WORKSHOP AGENDA

Planning Commission
June 16, 2026 @ 5:30 PM
For the June 30, 2026 Regular Meeting @ 6:00 PM

Planning Commission Report
Meeting: June 16, 2026

Item #: 3. **Site Plan - 1370 Heil Quaker Boulevard - Proposed Truck Parking on 2.51 Acres. Property located at 1370 Heil Quaker Blvd. (Tax Map 17, Parcel 28.01). ID (Interchange District) Zoning District. Property owned by Harsimranjeet Kaur. Requested by Huddleston Steele, Inc.**

Date: APRIL 06, 2026
Scale:
Sheet: C2.1 OF
Project No. 2018-15
Prepared By: MF

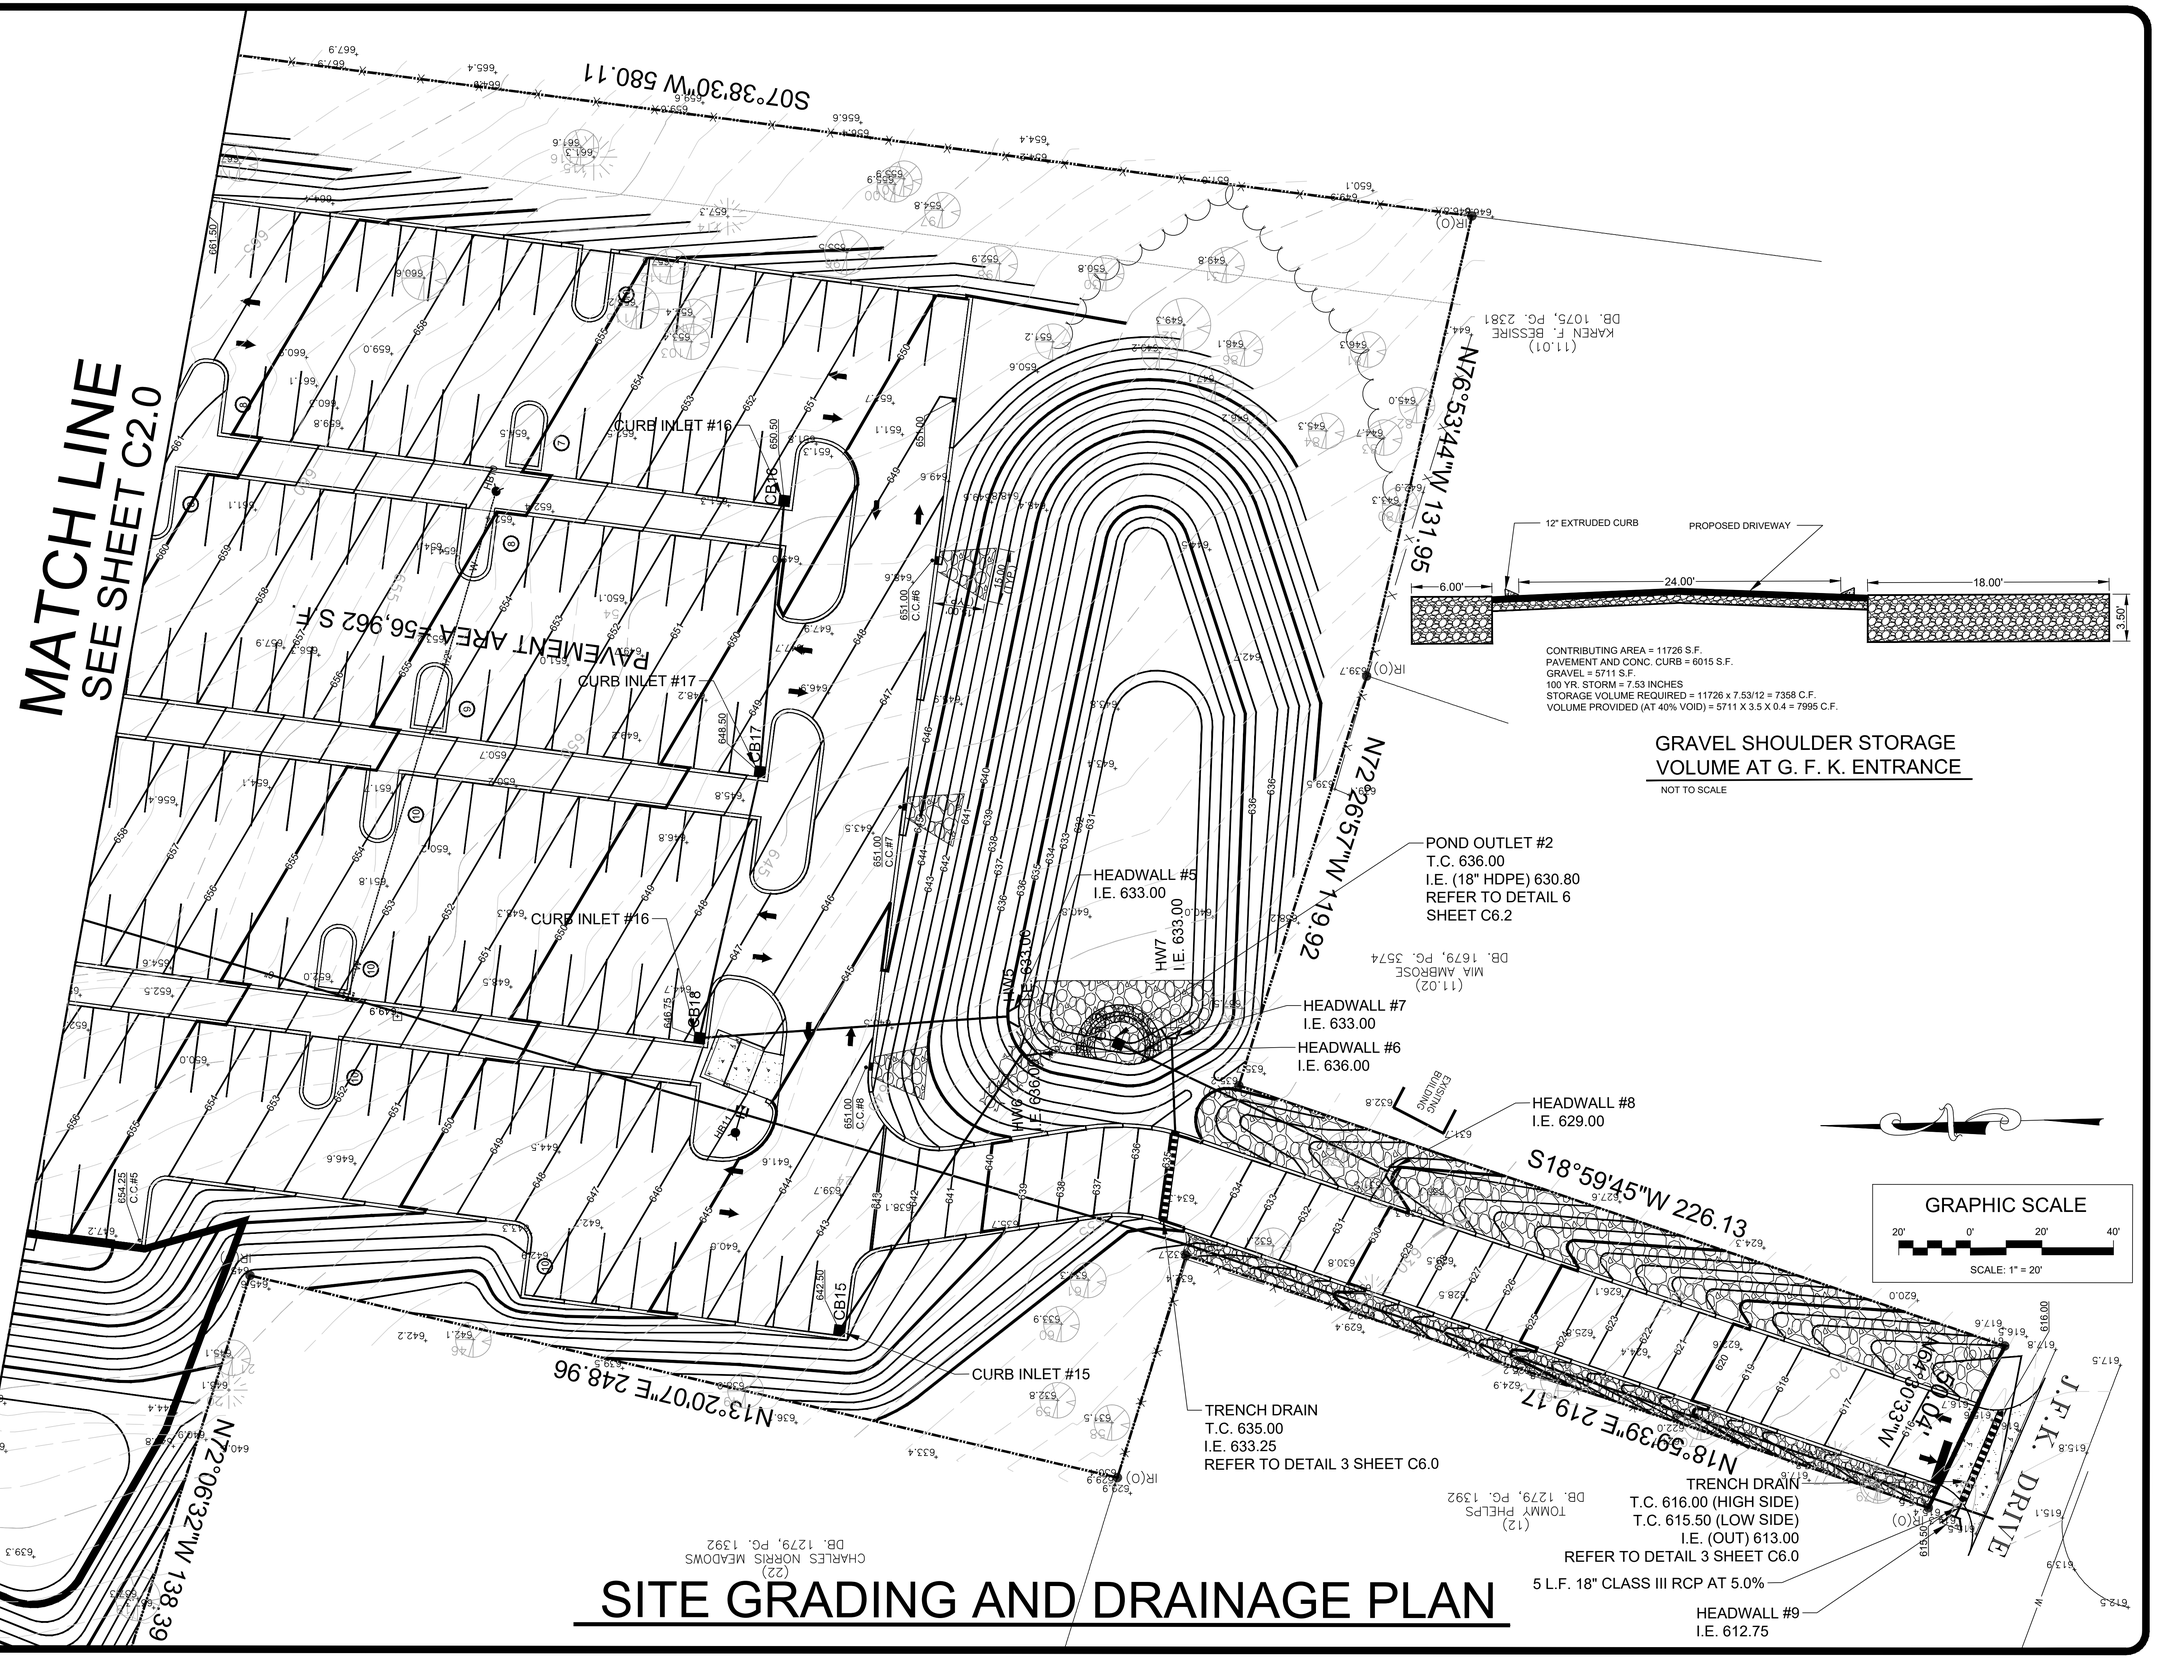
13. (Sheet C2.1) HW1 is assigned two different invert elevations on the plans. Clarify.

14. (Sheet C2.1) Provide elevation of the retaining wall along the Cherokee Drive frontage north and south of the three-lane entrance drive.
15. (Sheet C2.1 and Calculations) Provide calculations showing how the outflow of HW1 will go over the sidewalk and confirming that the roadside ditch will be able to handle the 25-year/24-hour storm without overtopping into the public road.

16. (Sheet C2.1) Curb cuts 1 and 2 appear to be dropping water about 2 to 3 feet. Please show how energy from the water will be dissipated to avoid erosion in the city right-of-way.

18. (Sheet C2.1) Contours 659 through 667 are not shown tying to existing contours. Please fully connect all contours so that limits of grading are clear. It appears that a retaining wall may be needed to keep the construction area on site.

19. (Sheet C2.1) Provide a site profile from the easternmost parking space at the top of the page to the nearest property to the east showing existing and proposed grades.

20. (Sheet C2.1) Show pedestrian/ADA access to the soccer field. If it will not be ADA accessible, state reasoning.

Date: APRIL 06, 2026
Scale:
Sheet: C2.2 OF
Project No. 2018-15
Prepared By: MF

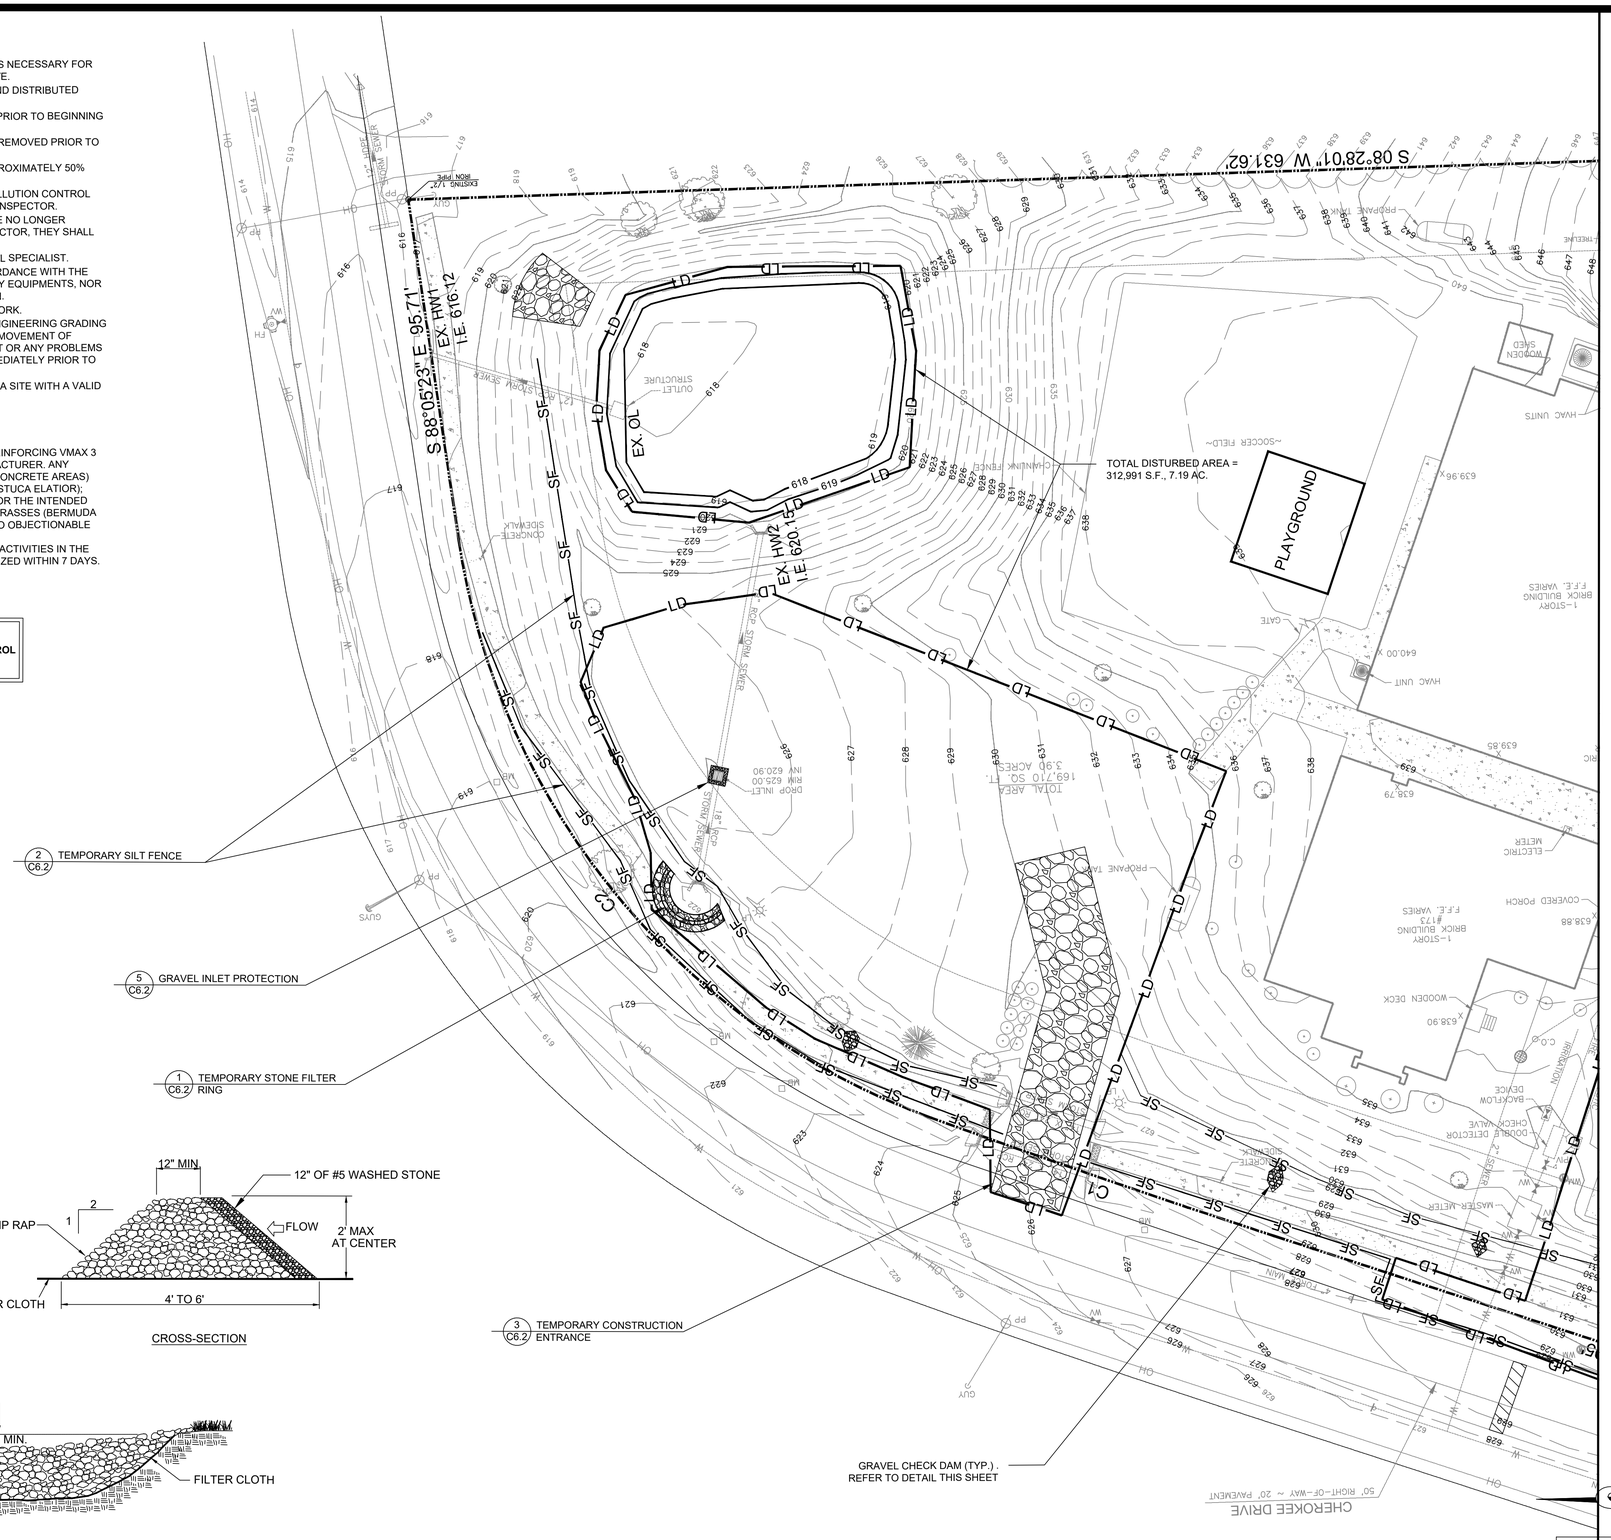
17. (Sheet C2.2) Provide calculations and manufacturer's information that demonstrate that the flow from the driveway will be captured by the trench drain before going into JFK Drive.
